**Amendments to the Drawings:**

S/N: 10/635,344  
Reply to Office Action of April 18, 2005

Title: HOLLOW CATHODE SPUTTERING APPARATUS AND RELATED METHOD  
First Named Inventor: Alan E. Delahoy  
Application Serial No.: / Atty. Docket No.: ENPI 0101 PUS

Figure 2

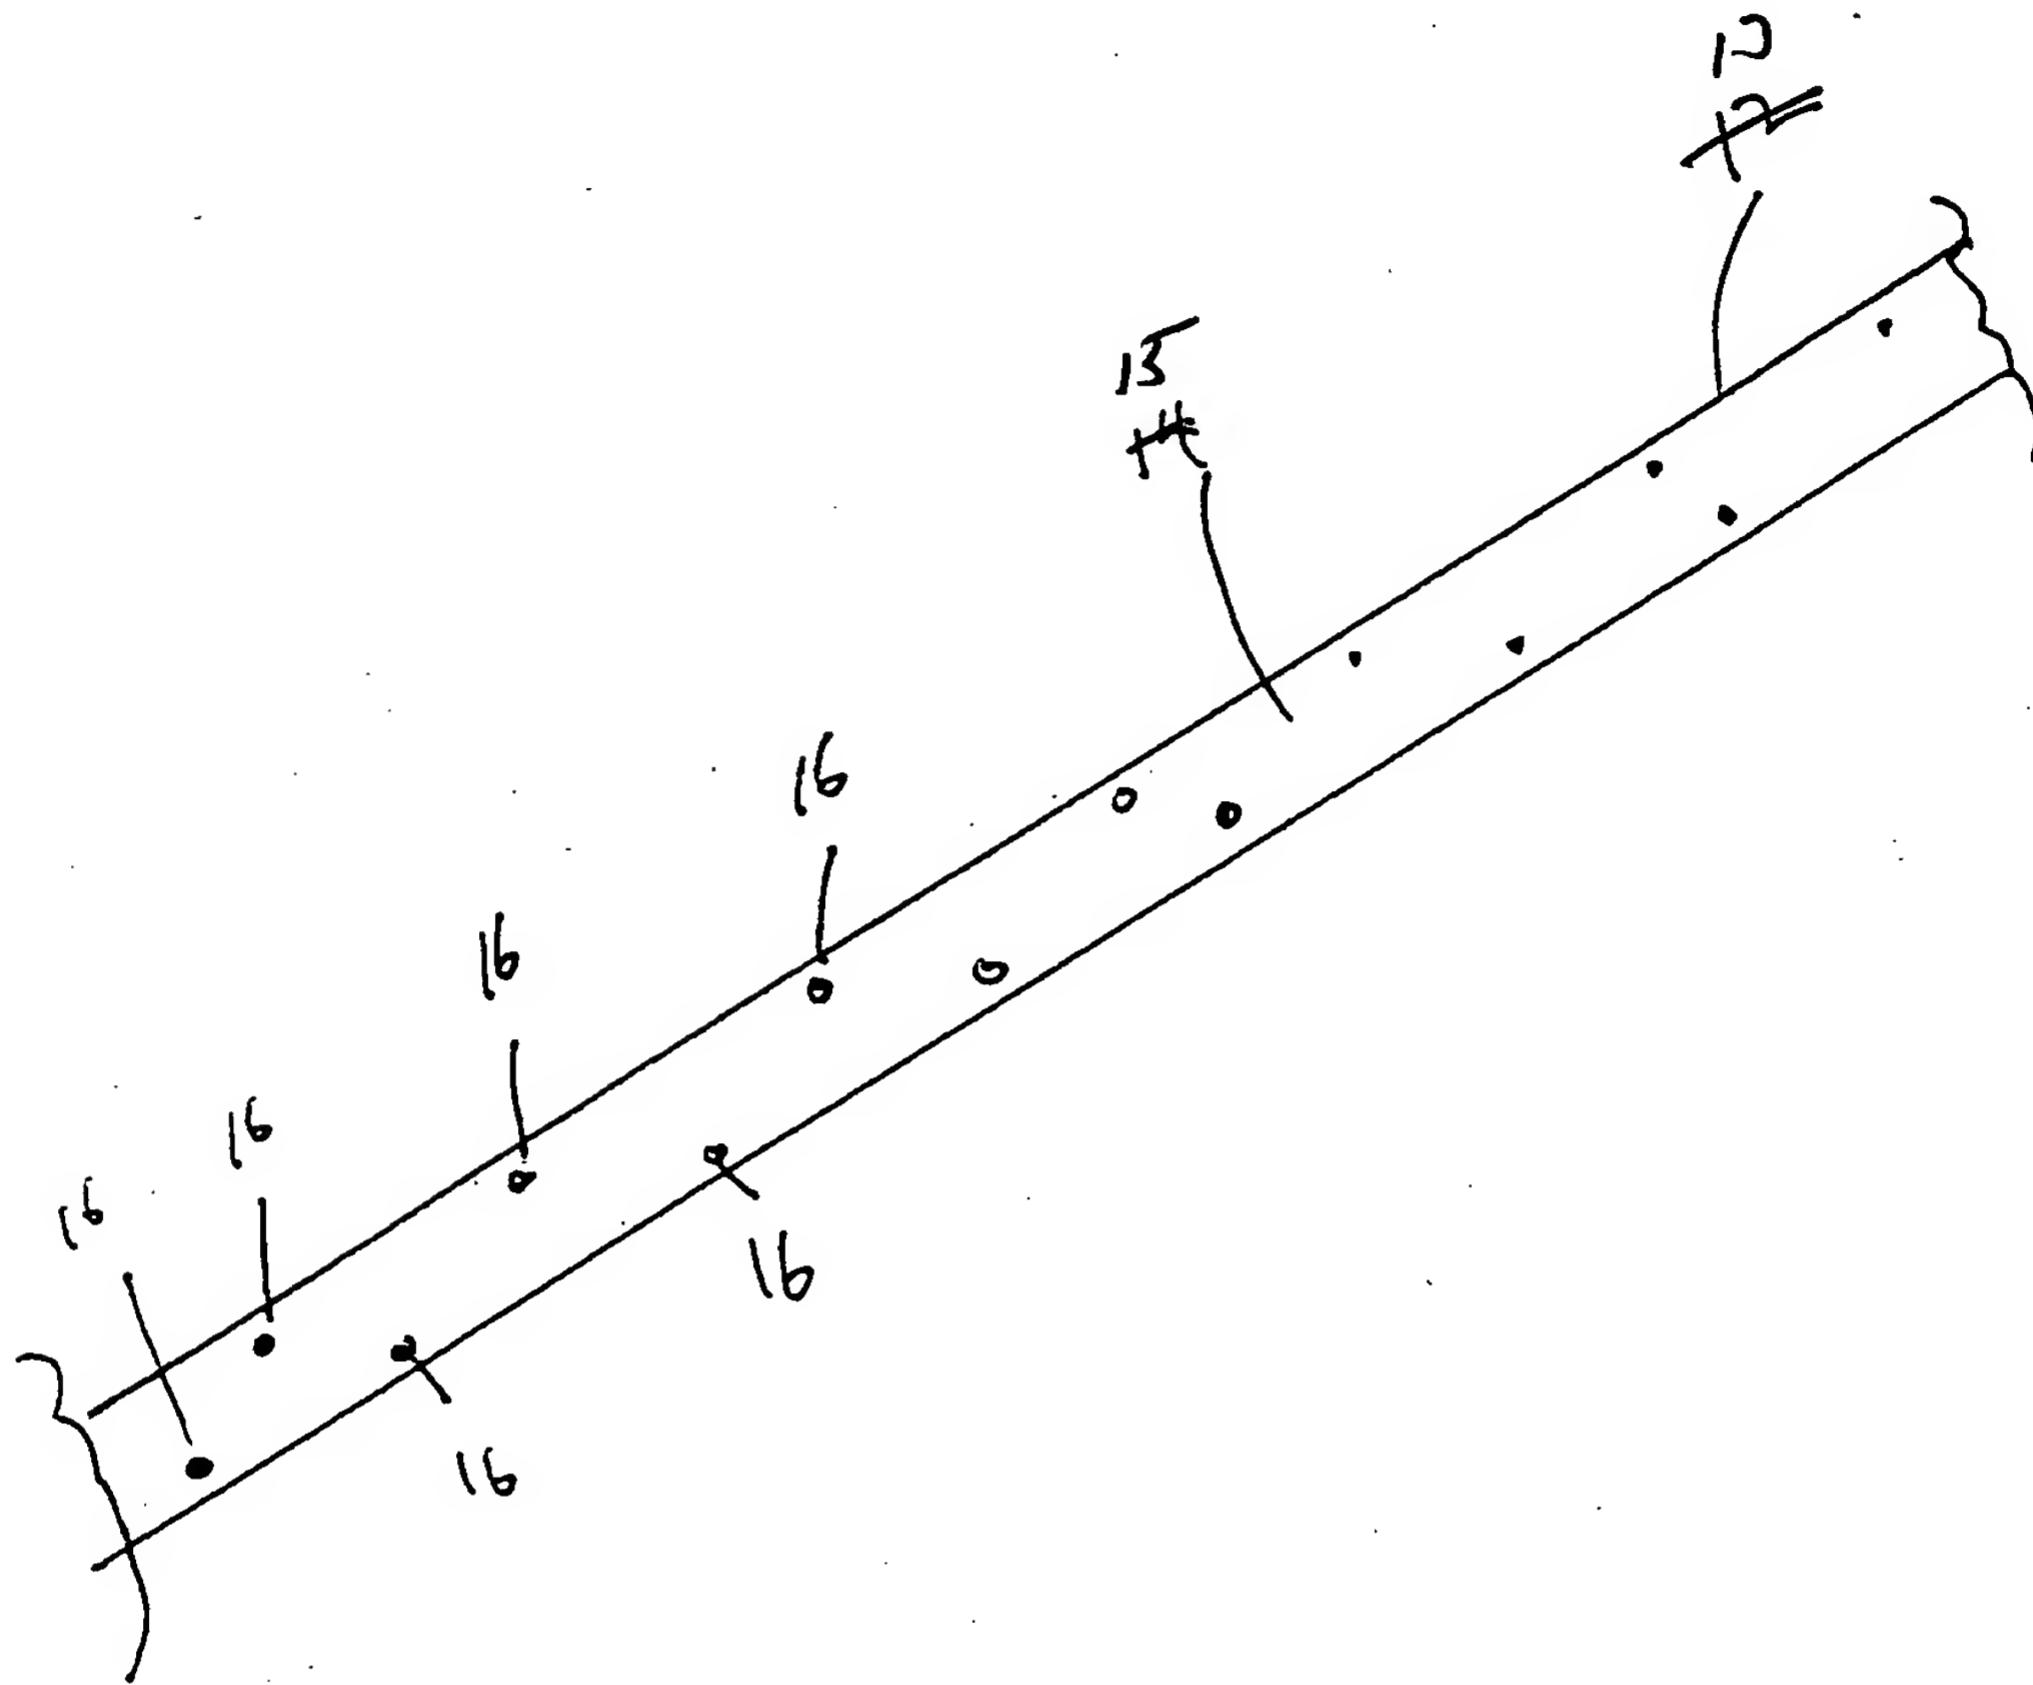
In the Drawings, Figure 2 is amended to replace redundant item numbers 12 and 14 with 13 and 15. Similarly, Figure 4 is amended to replace a redundant occurrence of “34” with “36”. Figure 5B is amended to replace redundant occurrences of items 106 and 110 with 100 and 102. The appropriateness of this correction is evident from the Specification on p. 13, ll. 26-28 which states:

Figure 4

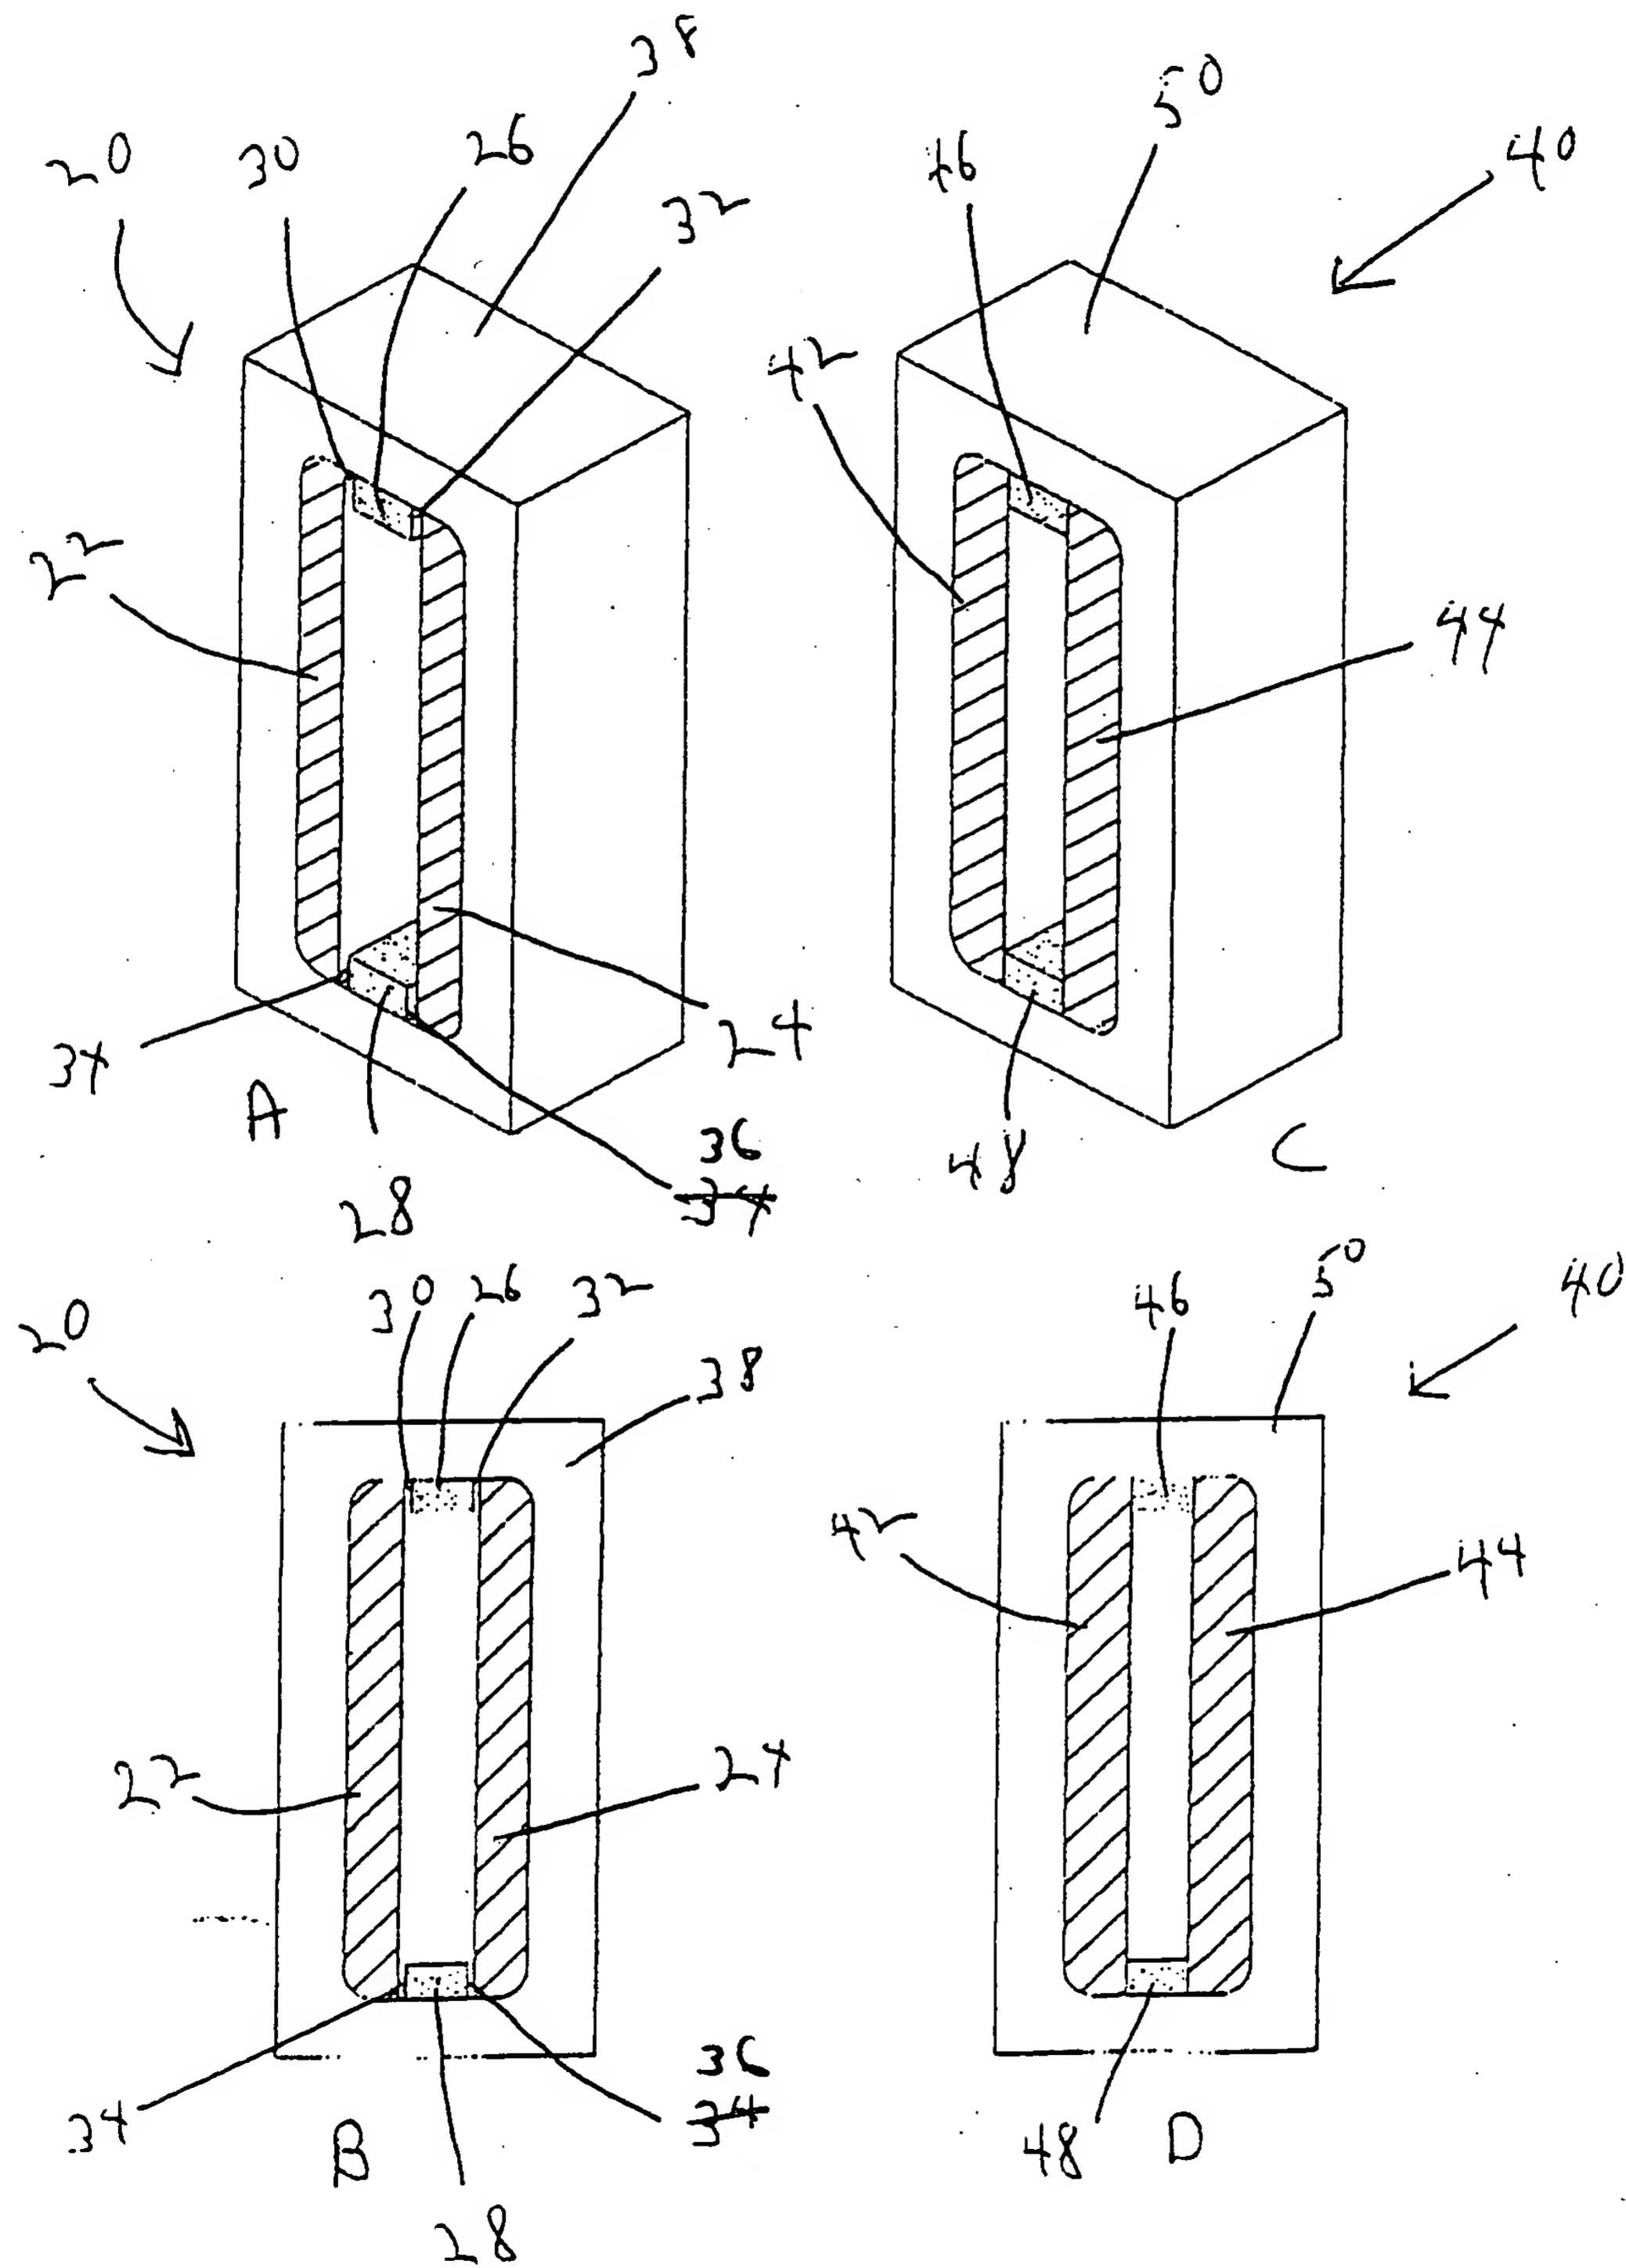
The drawings are objected to as failing to comply with 37 CFR 1.84(p)(5) because they do not include the following reference sign(s) mentioned in the description: 36 (see page 9, line 30); 100 (see page 13, line 27); and 102 (see page 13, line 28). As set forth above, these items have been corrected.

Figure 5B

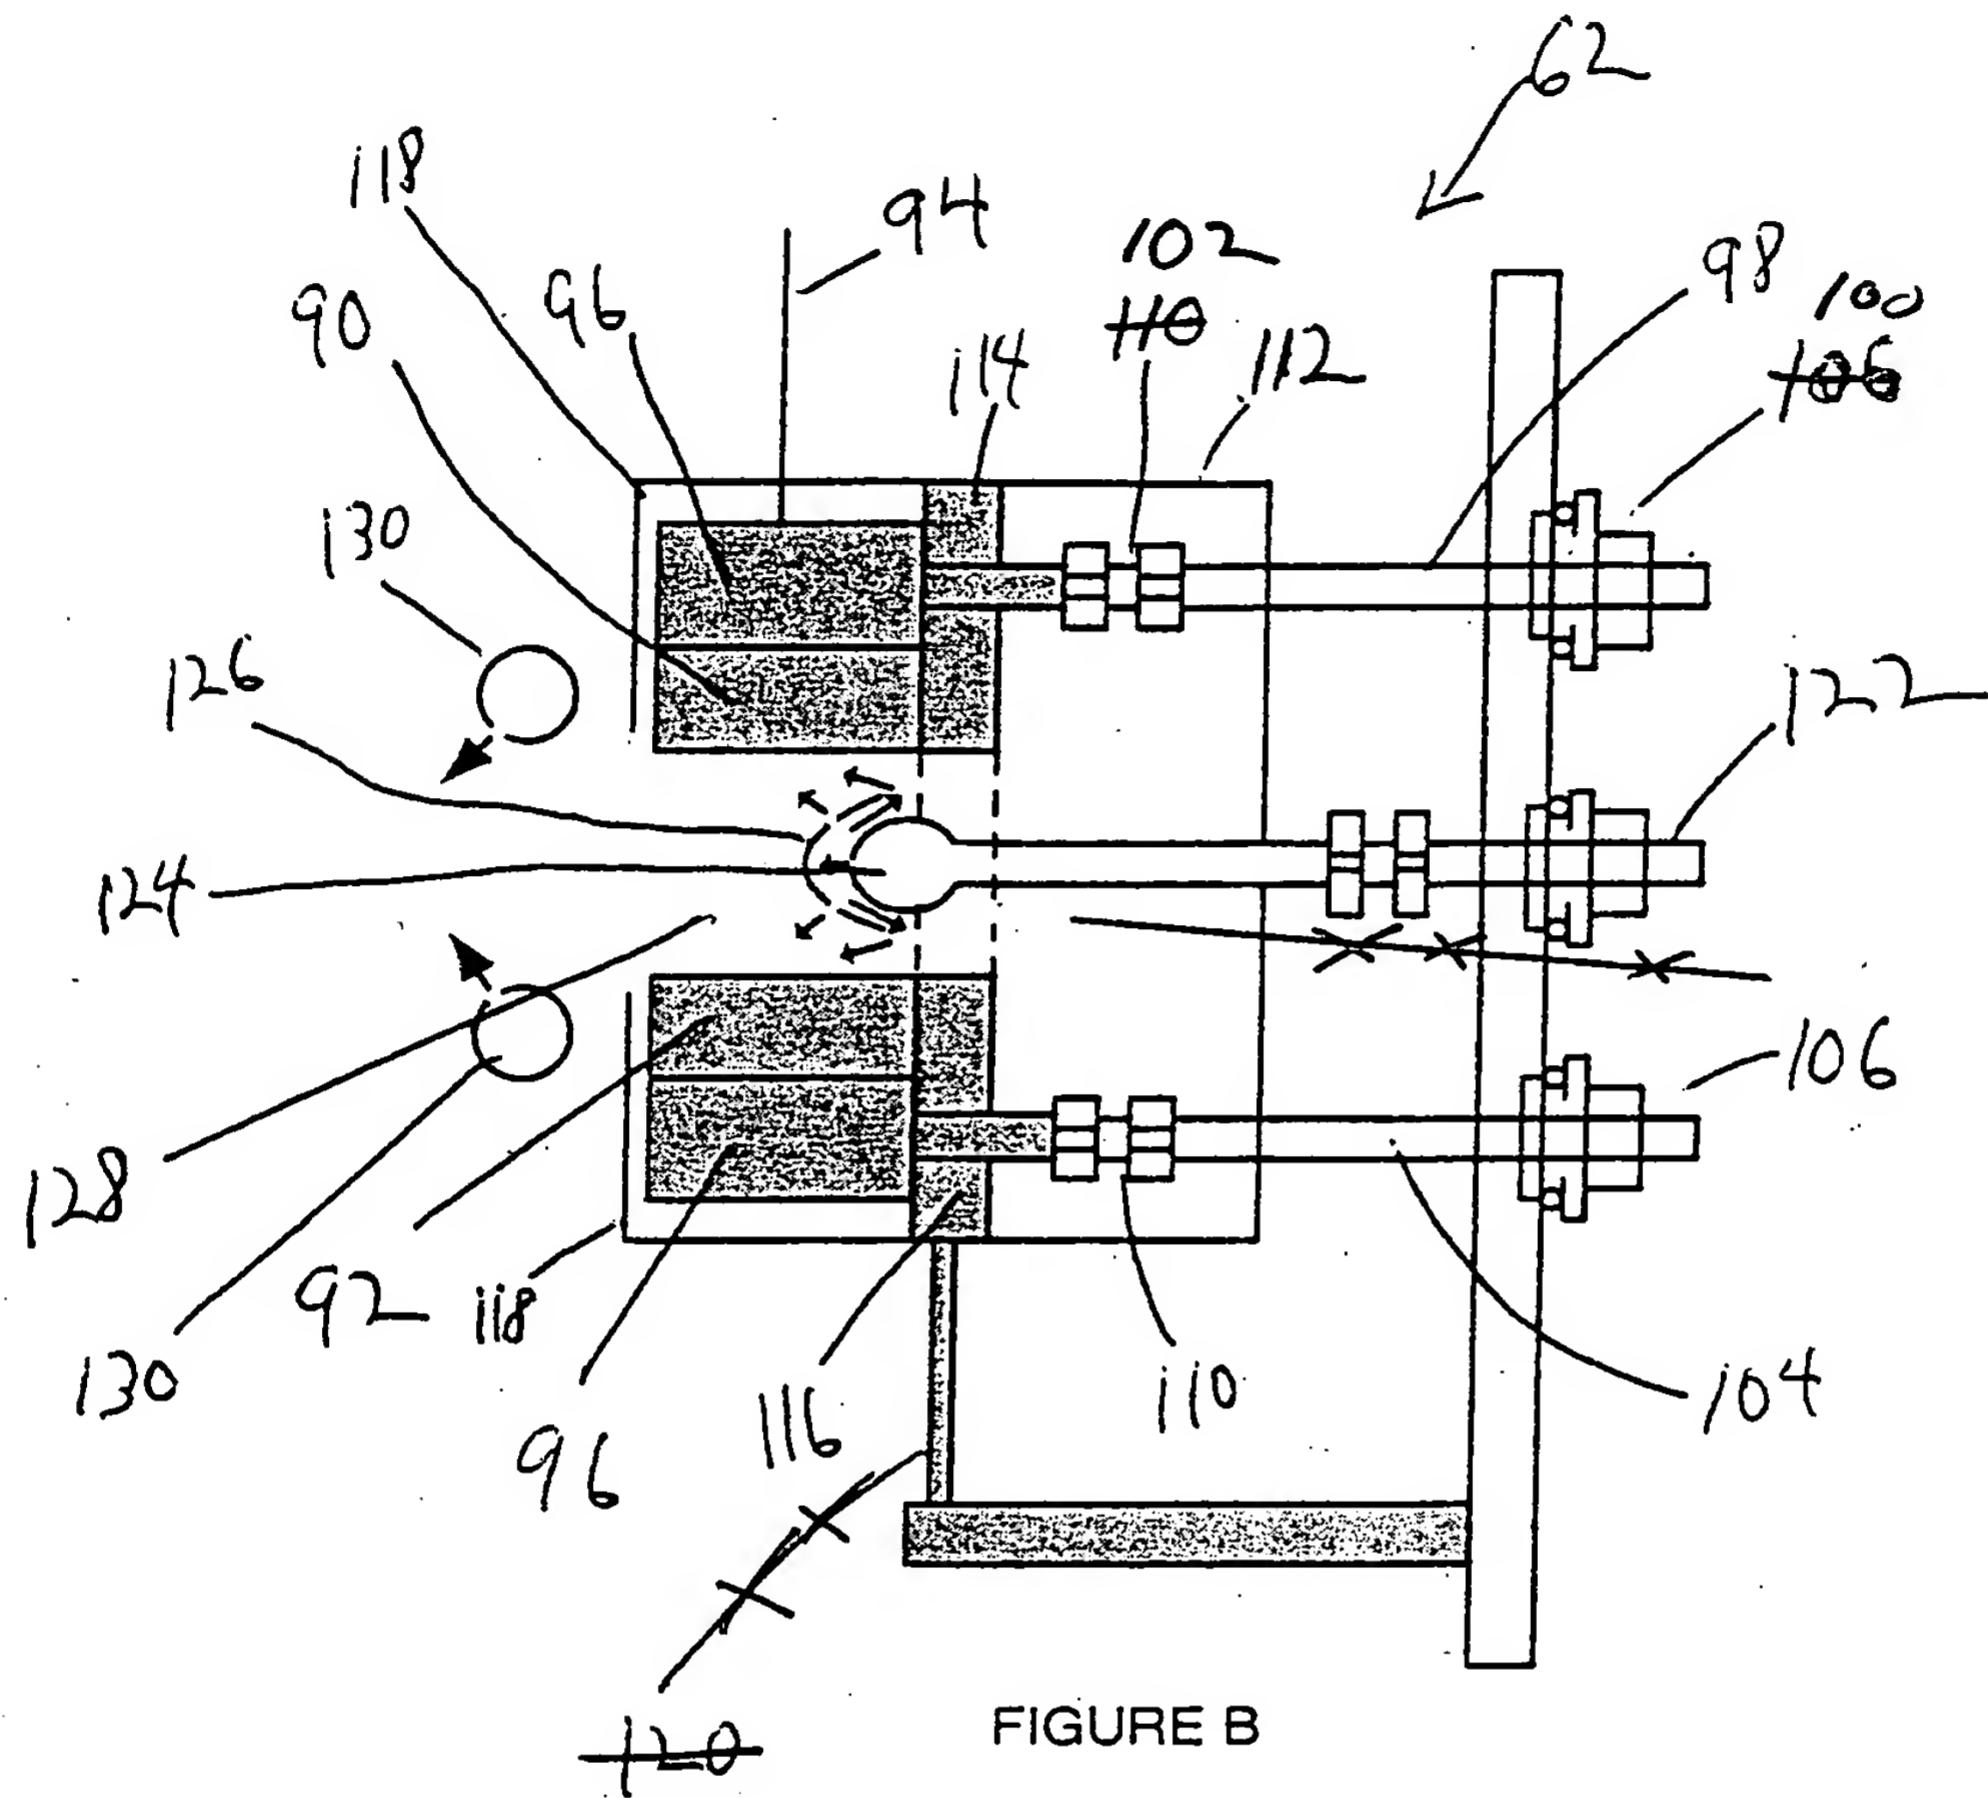
Water is introduced into copper cooling block 96 through teflon tube 98 which snakes through leak tight adapter 100. Teflon tube 98 attaches to copper cooling block 96 via connector 102.

Figure 5B is further amended to remove item number 120.
